TRAFFIC AND ACCESS REPORT  
FOR PROPOSED WAREHOUSE,  
DISTRIBUTION CENTRE AND  
OFFICE DEVELOPMENT,  
74 EDINBURGH ROAD,  
MARRICKVILLE

OCTOBER 2020  
(UPDATED JANUARY 2021)

Appendix E - Responses to submissions

20.0m ARTICULATED  
VEHICLE SWEEP PATHS

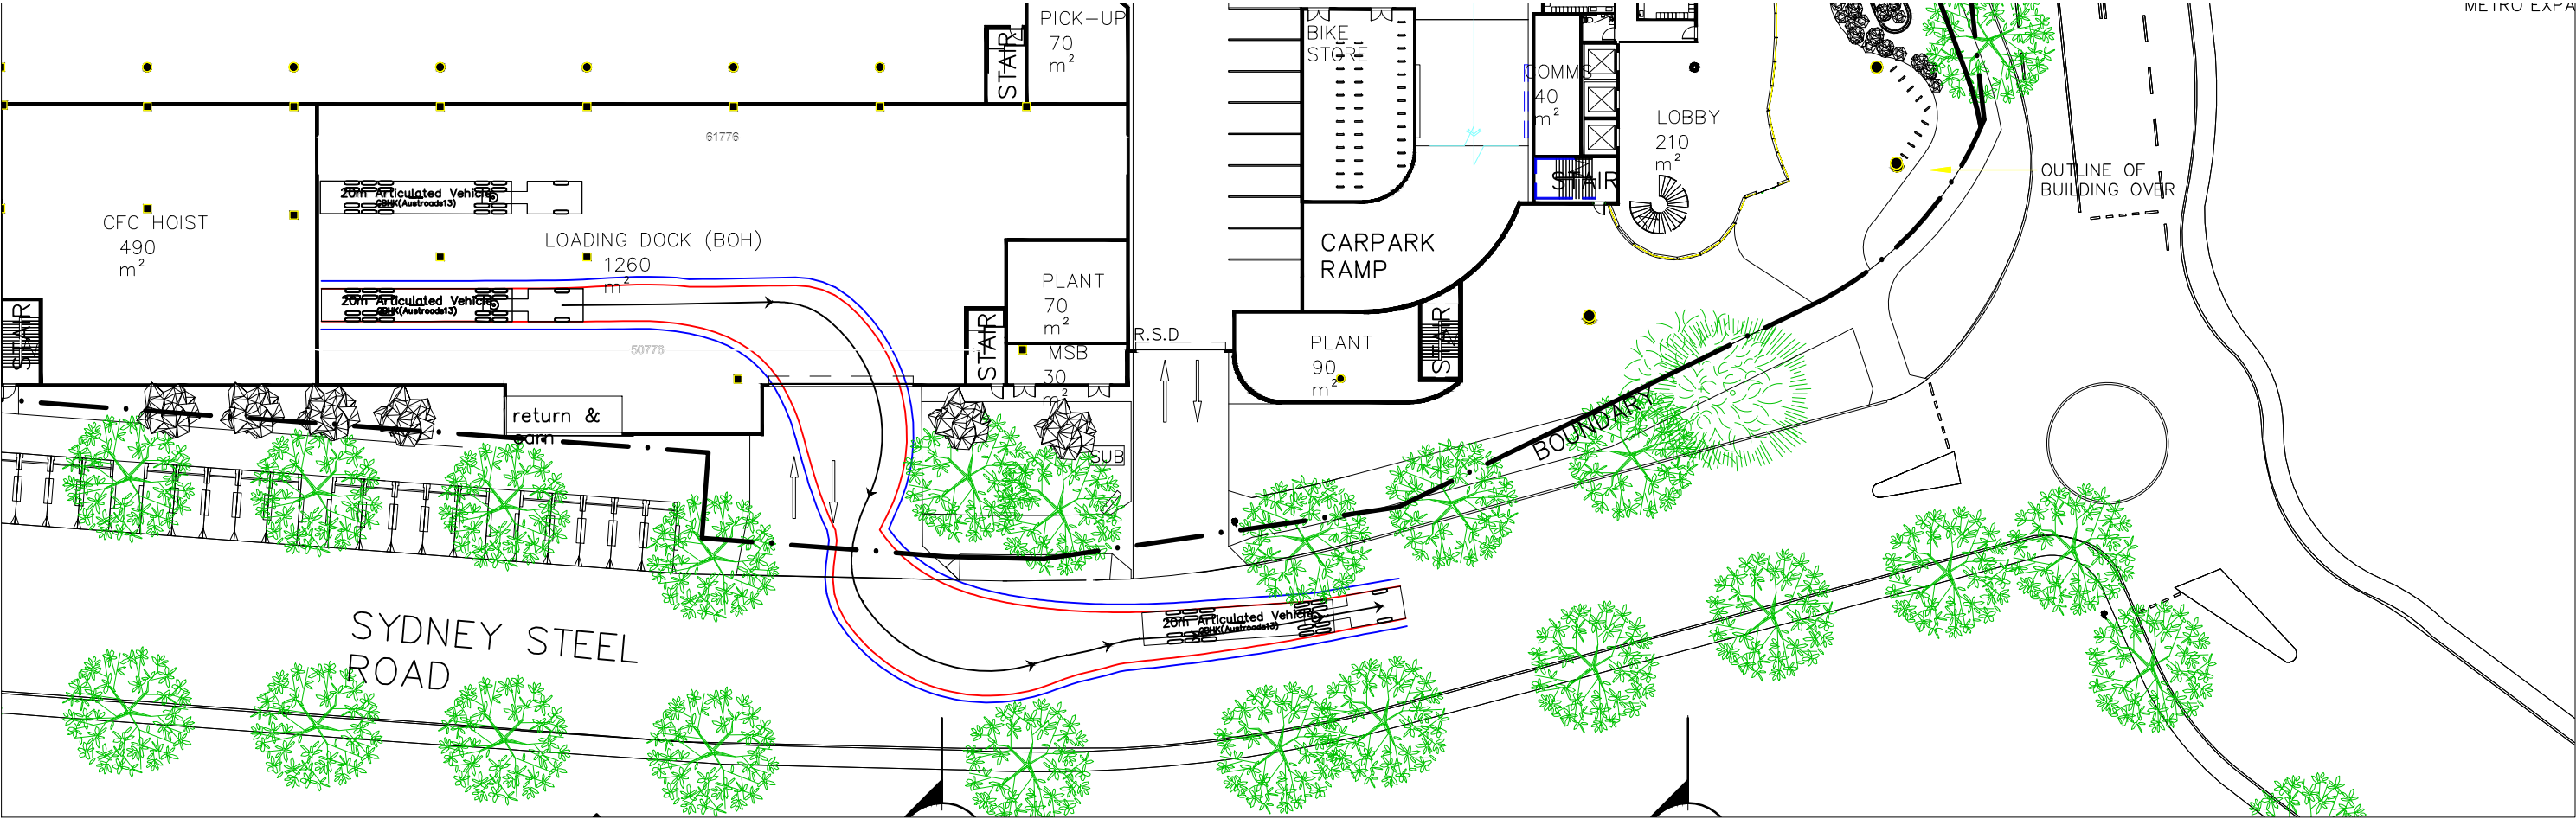
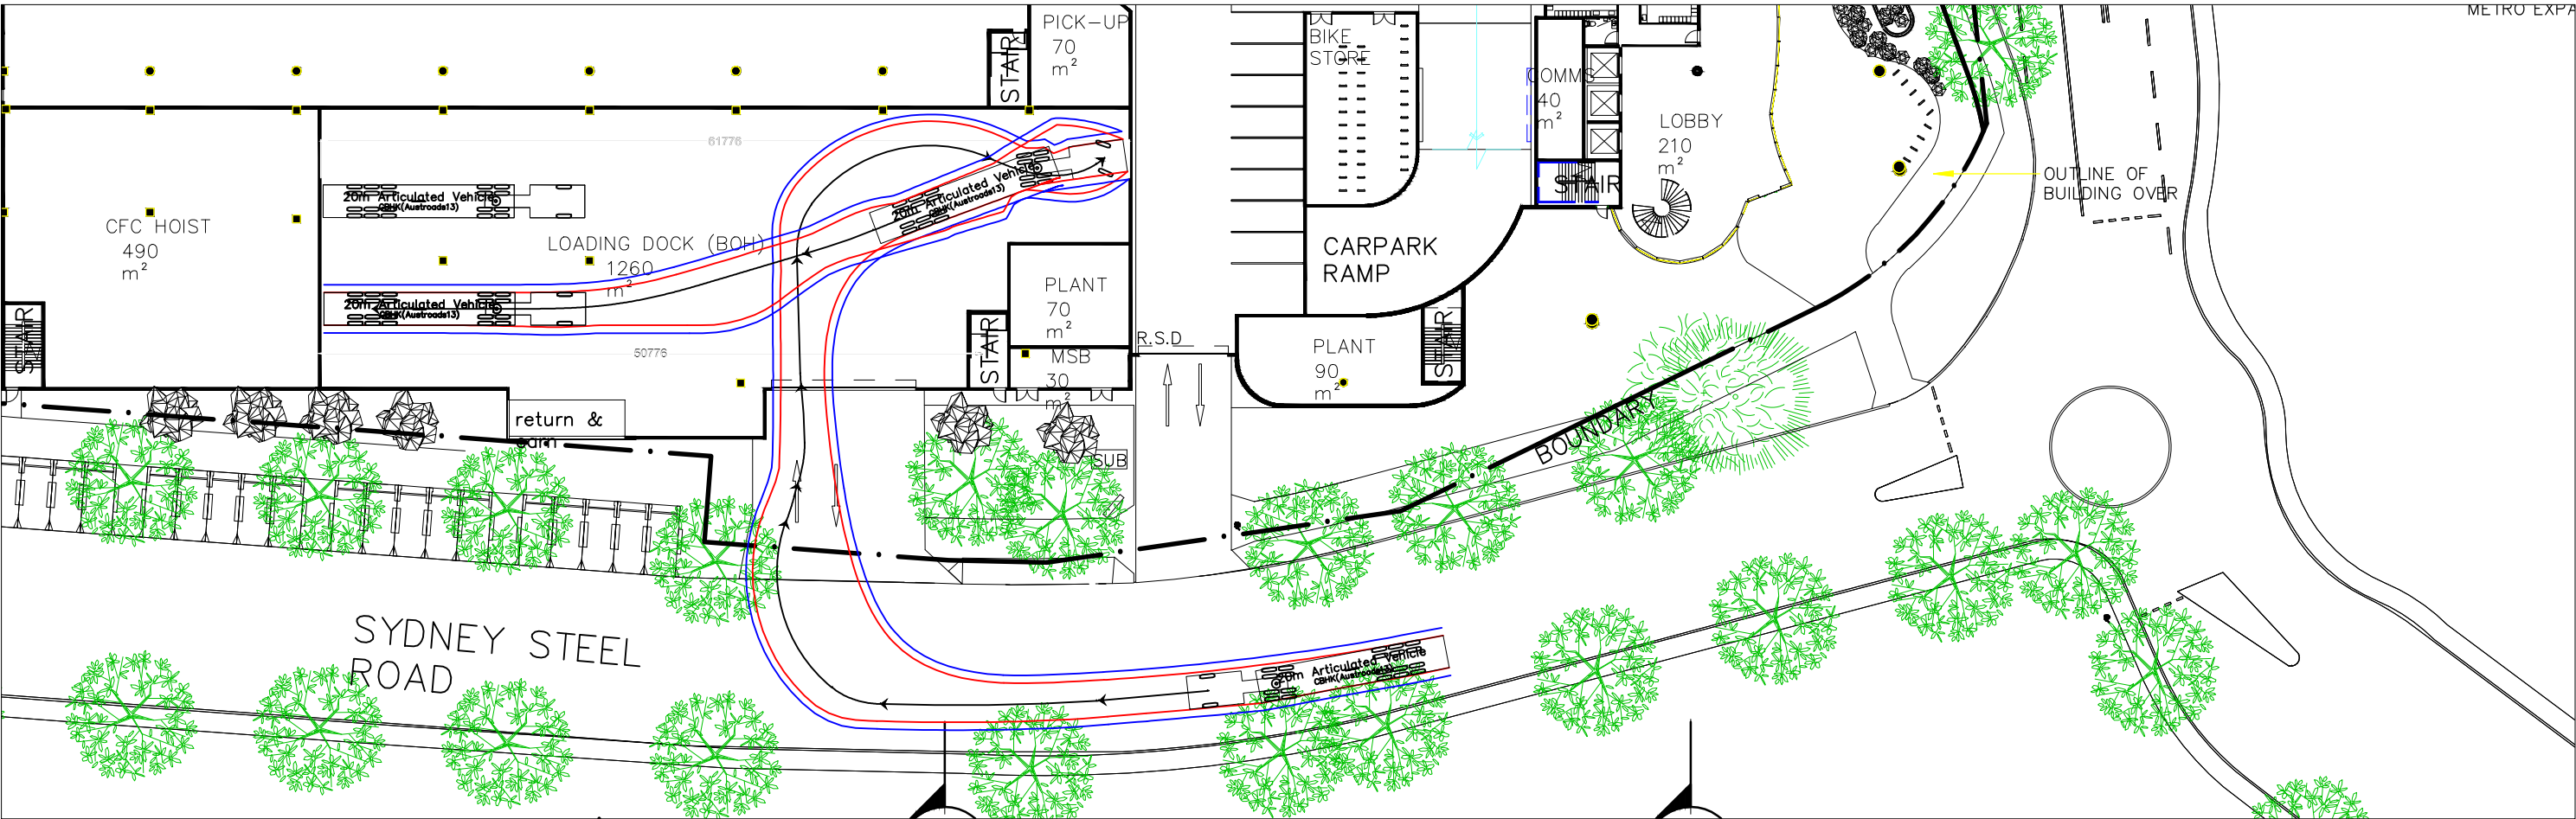
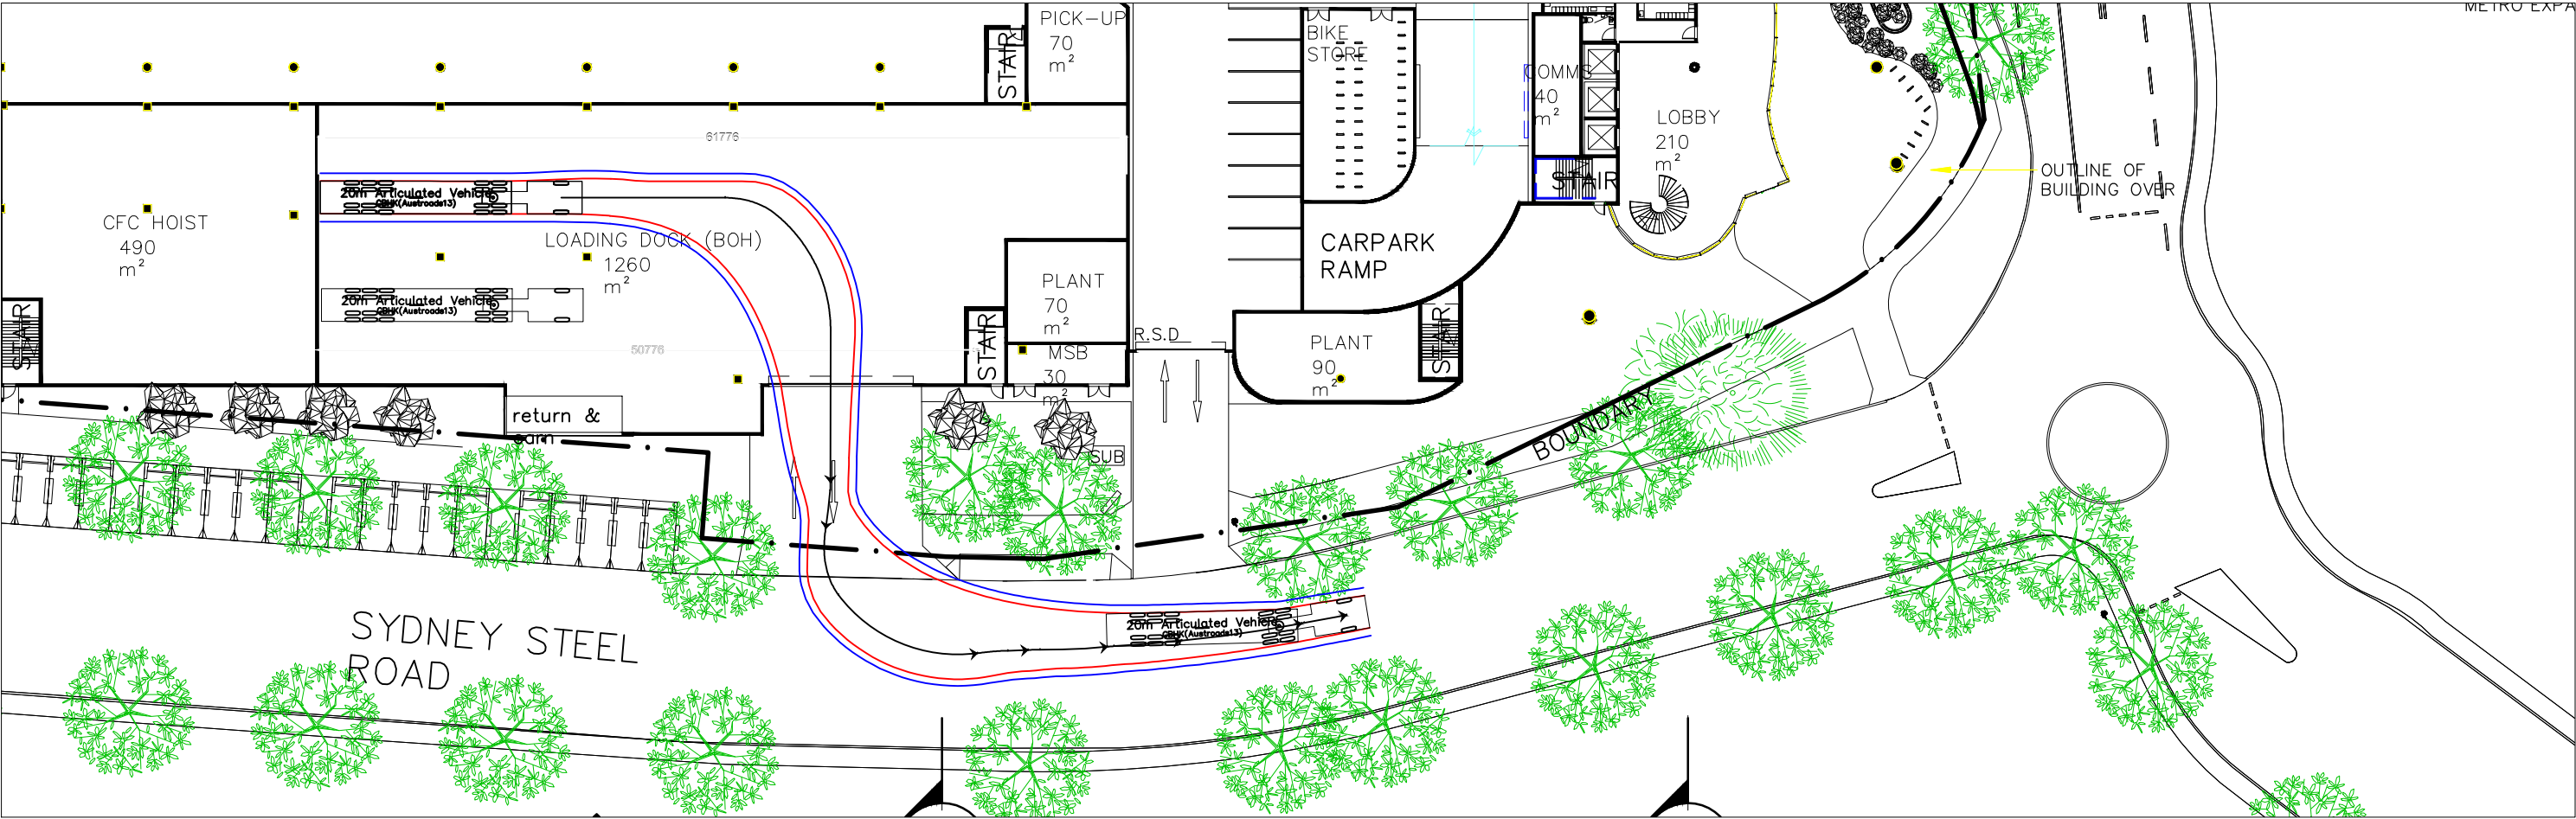
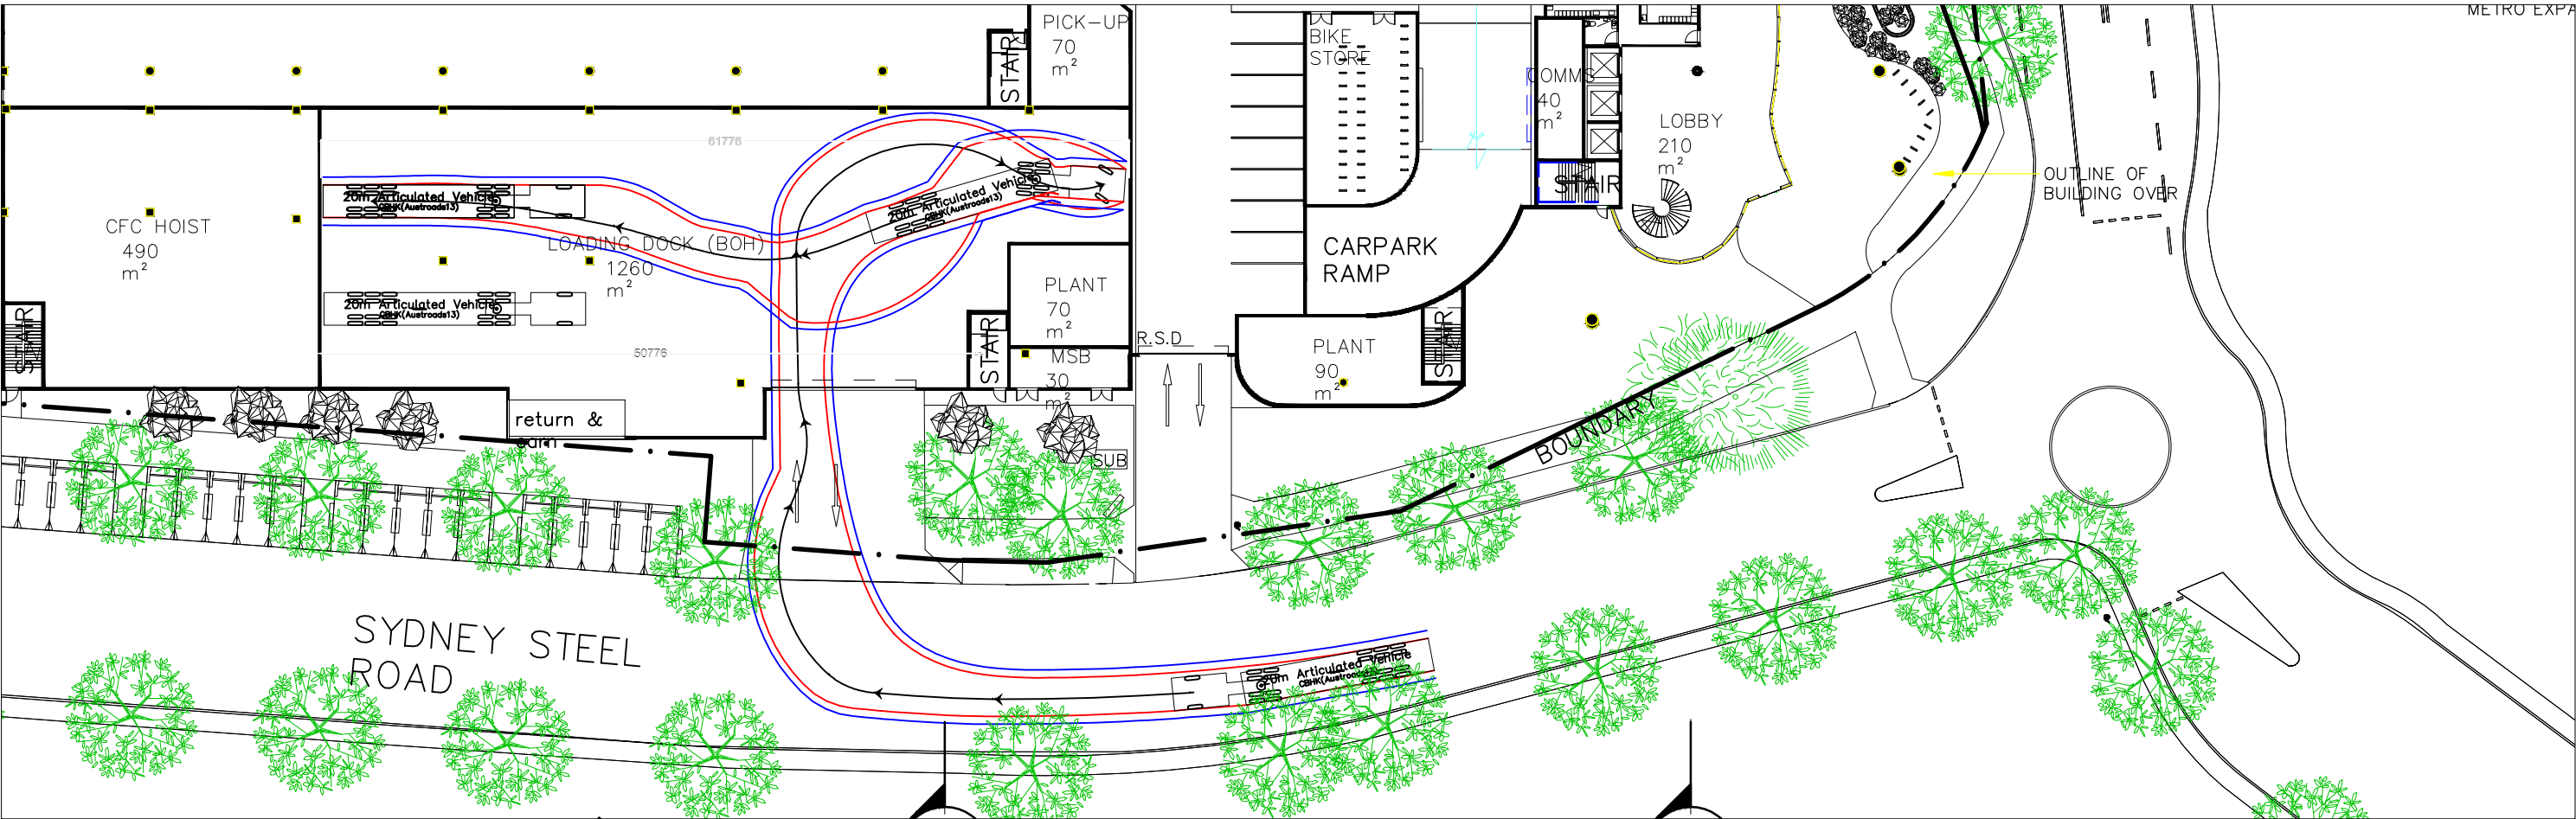
*TfNSW has reviewed the internal swept paths for the site and notes that the semi-trailer movement (Sheet 9 in the TIA) is only illustrating the end docking space being utilised. For the other seven loading dock spaces to be utilised, TfNSW believes that the movements may encroach on the car parking spaces.*

14. The western-most dock was included as this is the most constrained in terms of manoeuvring area. Semi-trailers will be able to access all docks, as shown in the attached Figure 1.
